■ Band voltage modification

If you want to connect an external unit which can be controlled by the band voltage from [ACC] connector, the modification is necessary as at right.

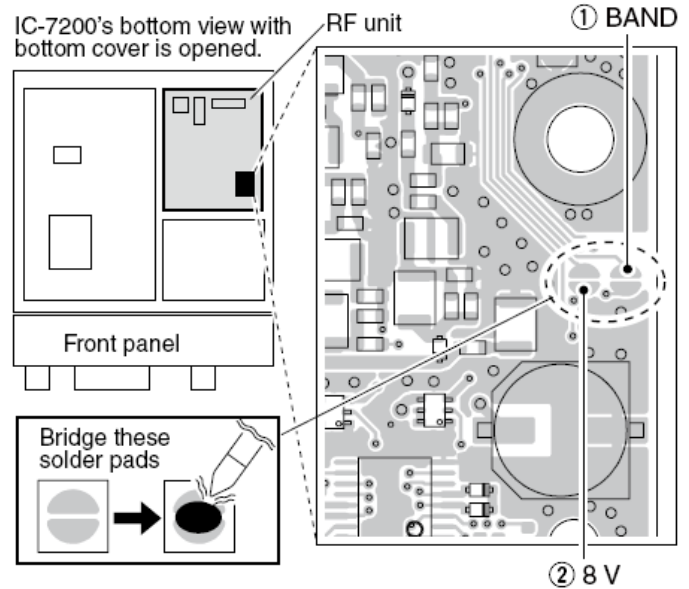
The band voltage appears from pin 5 of [ACC] connector after modification (①) is completed, or the regulated 8 V appears from pin 1 of [ACC] connector after modification (②) is completed.

• Band voltage generator circuit

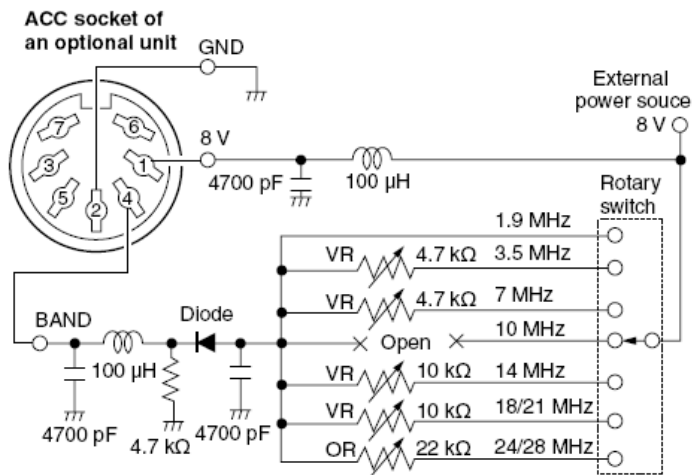
The below circuit is just for reference.

The following band voltage table is for reference only. Please adjust and confirm against the actual operating condition.
